EAGLE GOLD PROJECT

Response to October 2012 YESAB Request for Additional Information
(YESAB Assessment 2010-0267)

Date:
November 23, 2012

Figure 1. Heap Leach Facility Draindown Curve

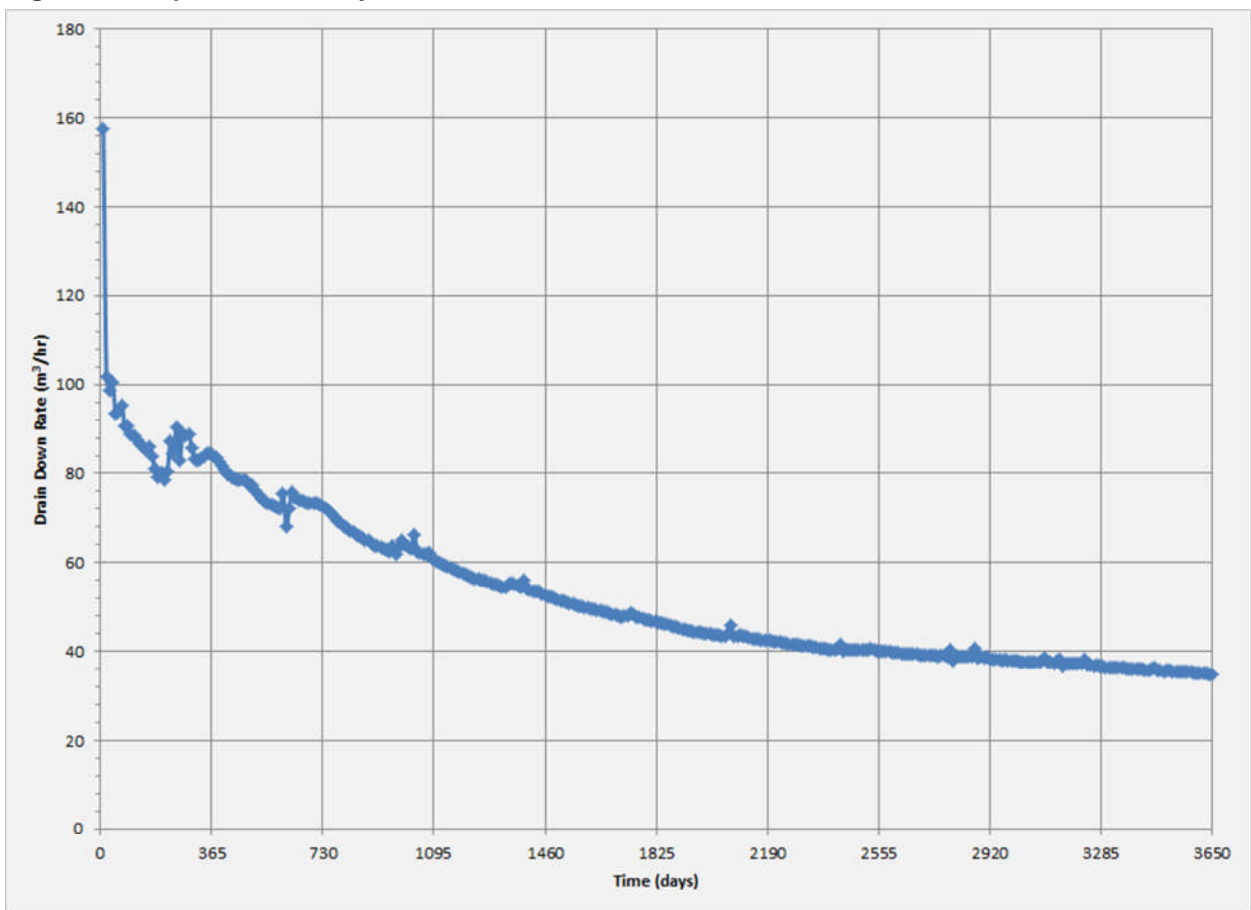
The HLF water balance tables appear to assume that, once the moisture content of ore under leach reaches 13.3 percent, it will not be released until mining and leaching are finished over the entire HLF. This does not appear to be a correct assumption as sequencing of leaching and ore placement will result in varying degrees of moisture content within the HLF. As indicated by the Proponent (VIT 2012), areas under active leach will have moisture content around 13.3 percent as process leach solution is recycled to that area. Once active leaching ceases in that area, moisture content will decrease, to between 5-13 percent, as leach solution drains down.

- R1. Provide additional information on the Heap Leach Facility water balance model addressing concerns outlined by the First Nation of Na-Cho Nyak Dun including:**
- a. how the model accounts for the sequencing of leaching and ore placement, and;**
 - b. extent to which the model is able to predict operating conditions.**

The revised draindown model indicates that rate of HLF draindown will begin at the design irrigation rate of 2,770 m³/hr and decline quickly. It is estimated that after the completion of rinsing, approximately 344,000 m³ of rinsate solution will draindown from the heap in the first ten days and this grows to approximately 399,000 m³ after 30 days and approximately 536,000 m³ after 90 days. During this initial period of draindown, the combined storage capacity of the In-heap Pond and Events Ponds will be sufficient to store at least 382,000 m³ of rinsate (i.e., In-heap Pond of 199,400 m³ + Events Ponds of 183,000 m³) before requiring discharge to the MWTP. The total storage capacity of the system is 733,000 m³. Recirculation of rinsate back to the top of the heap will be conducted so that the capacity of the MWTP is not exceeded. The actual amount of rinsate that will be delivered to the MWTP is a function of the rate of other flows also reporting to the MWTP. This is described more fully in Attachment C (Knight Piesold 2012).

As shown in Figure 1, the draindown model predicts that baseline rate of draindown continues to decrease quickly to approximately 91 m³/hr (~25 L/s) after 90 days, 80 m³/hr (~22 L/s) after one year, 70 m³/hr (19 L/s) after two years, and approximately 35 m³/hr (~9.7 L/s) by the end of Year 10, ultimately approaching a meta-stable state associated with the average environmental contribution (i.e., precipitation – evaporation) of approximately
